Service Bulletin No: 53-010

Modification No: EC-09-0594

**FUSELAGE - GENERAL
INSPECTION FOR GALVANIC CORROSION ON THE UPPER LEFT LONGERON AND REPLACEMENT
OF THE CHAFING PLATES****1. Planning Information****A. Effectivity**

Canopy-lock Chafing Plates - Removal and Installation
Figure 1

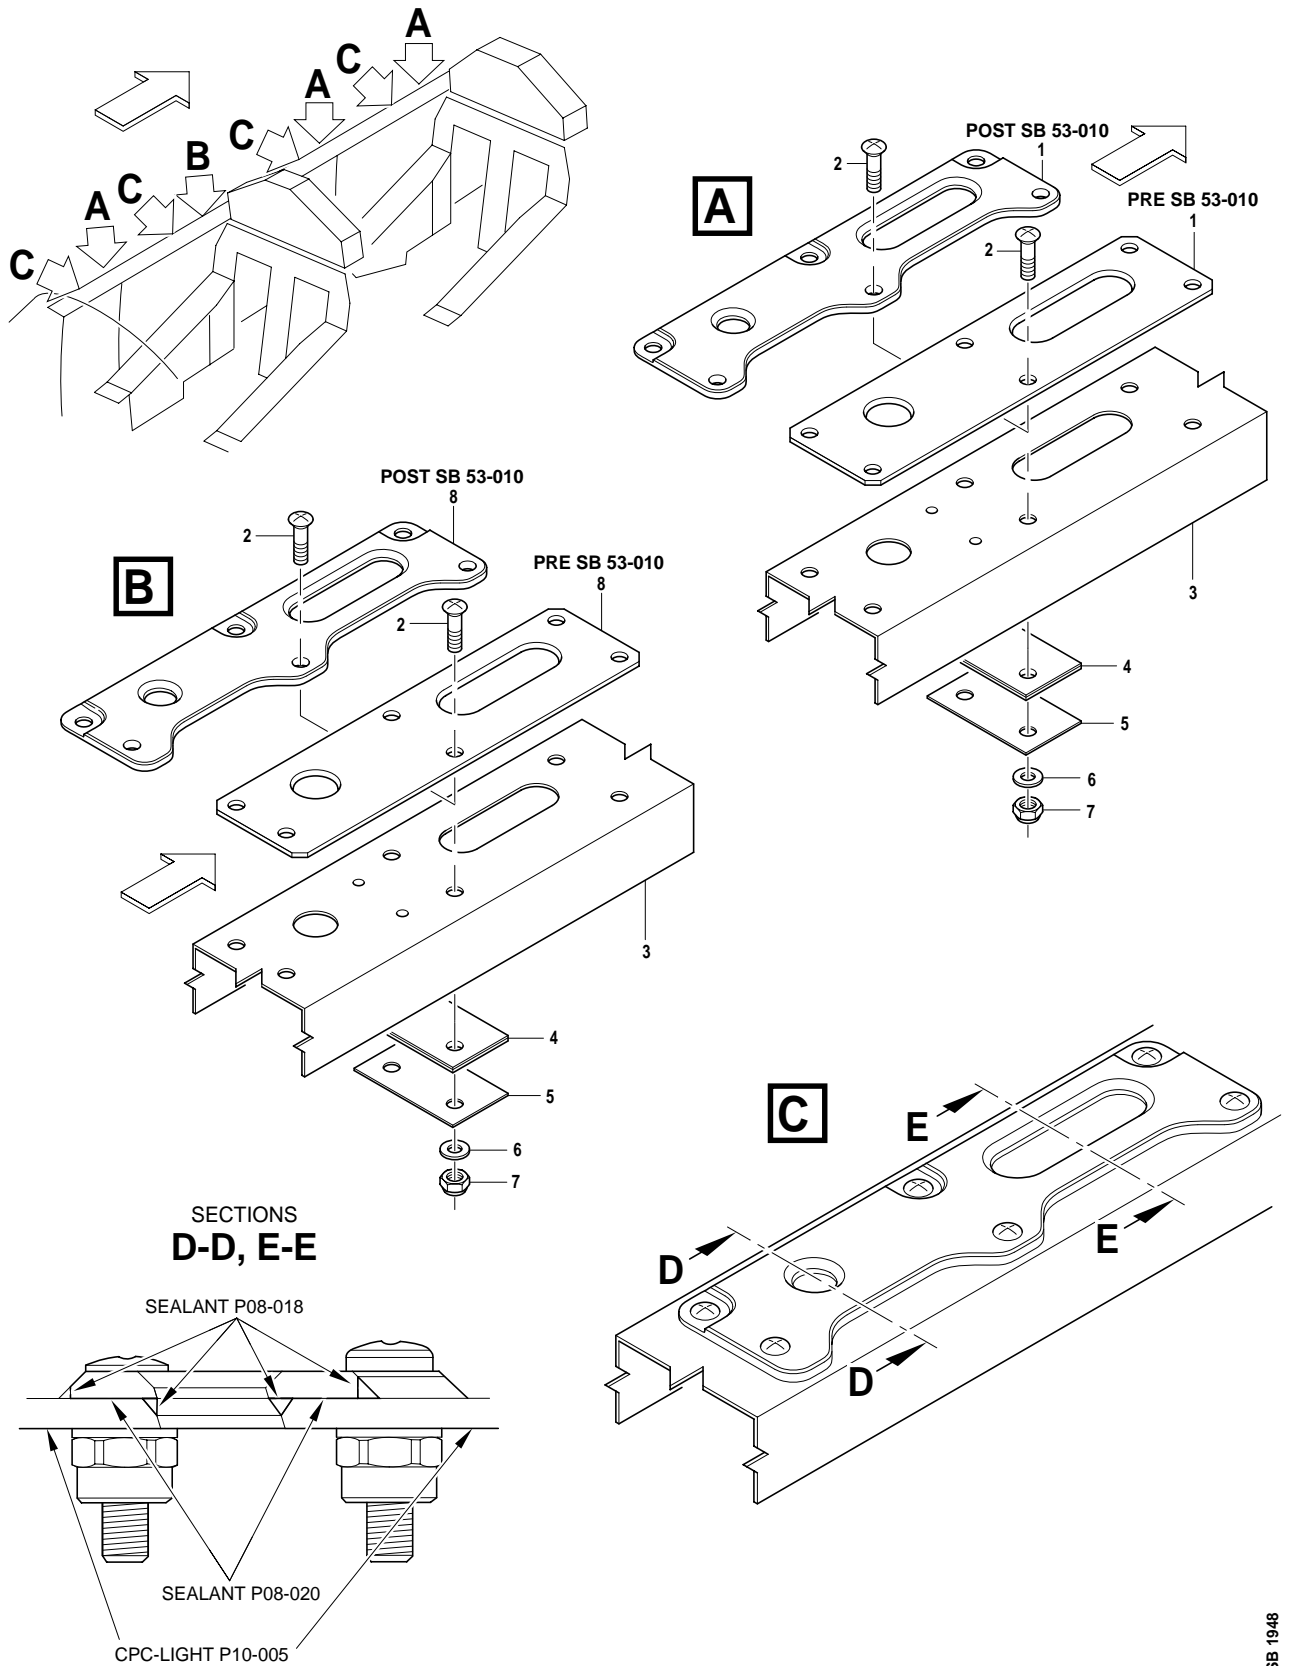
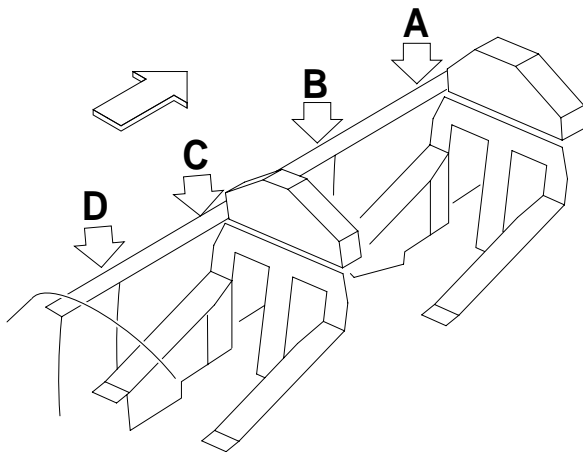
Corrosion has been reported on the upper left longeron underneath the chafing plates for the canopy door latches.

Do an inspection of the longeron in the specified areas and, if necessary, remove the corrosion. Apply to Pilatus for a repair scheme if the removal of corrosion decreases the metal thickness to less than the specified limits. Install new, more robust, chafing plates.

- (g) If the thickness of the remaining metal is less than:
- 1,8 mm (0.071 in.) at the FWD chafing plate (1) in the front cockpit
 - 2,3 mm (0.091 in.) at the AFT chafing plate (1) in the front cockpit
 - 2,1 mm (0.083 in.) at the FWD chafing plate (8) in the rear cockpit
 - 1,8 mm (0.071 in.) at the AFT chafing plate (1) in the rear cockpit,

- (i) If the recorded metal thickness in Para. 3.B.(2)(h) is less than:
- 1,8 mm (0.071 in.) at the FWD chafing plate (1) in the front cockpit
 - 2,3 mm (0.091 in.) at the AFT chafing plate (1) in the front cockpit
 - 2,1 mm (0.083 in.) at the FWD chafing plate (8) in the rear cockpit
 - 1,8 mm (0.071 in.) at the AFT chafing plate (1) in the rear cockpit,

- (k) Put the new chafing plates (1) (P/N 553.20.09.326) and (8) (P/N 553.20.09.327) in position on the longeron (3).
 - (l) Put the locking plate assemblies (5) and shim packs (4) in their recorded locations on the longeron (3) (Ref. Para 3.B.(1)).

- (m) Install the new screws (2) (P/N 935.63.11.065), the new washers (6) (P/N 938.77.11.111) and the new nuts (7) (P/N 938.07.68.303).
 - (n) Remove the unwanted sealant (Material No. P08-020).

- The chafing plates (1)
 - The chafing plate (8)
- As shown in Detail C and Section D-D and E-E.
- (q) Apply a layer of the CPC-Light (Material No. P10-005) to the lower surface of the longeron (3) in the areas of the chafing plates (1) and the chafing plate (8).

Feedback Form (Front Cockpit)
Figure 2, Sheet 1 of 2

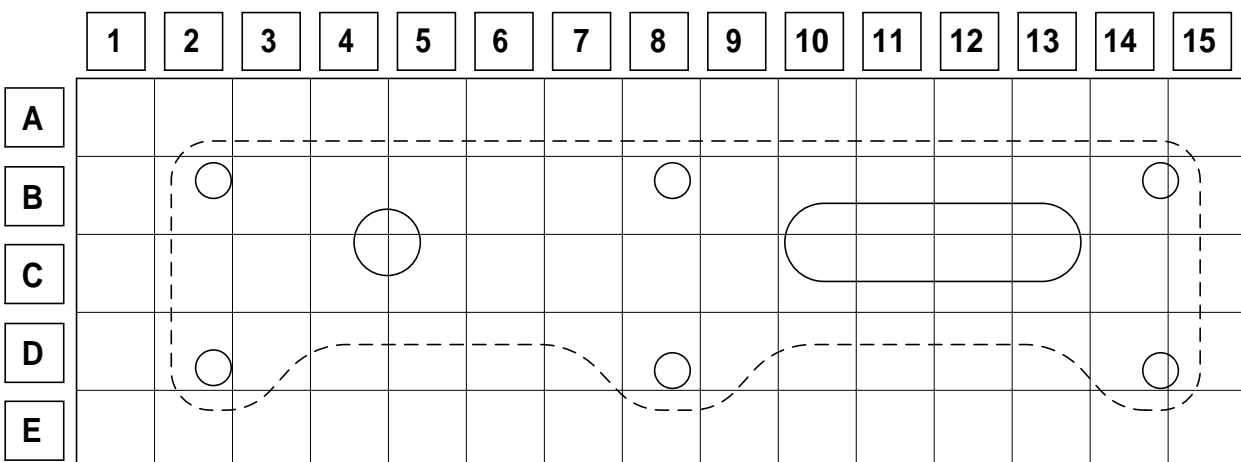
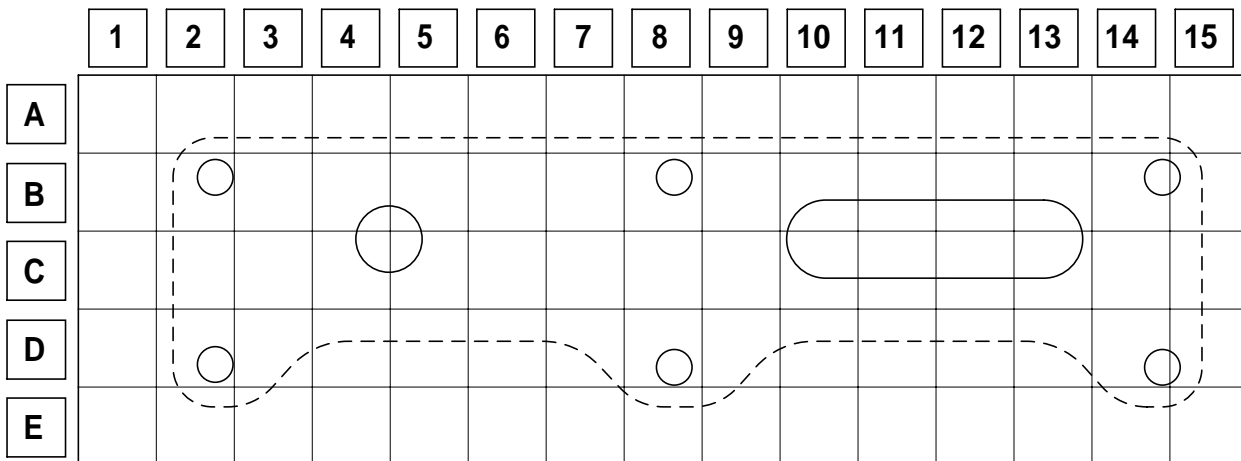
use the feedback form (Ref. Fig. 2) to record the values and apply to Pilatus for a repair scheme. The address is:

NOTE: The correct thickness of the metal is 2.7 ± 0.2 mm (0.106 ± 0.008 in.). You can use the feedback form (Ref. Fig. 2) to record the values.
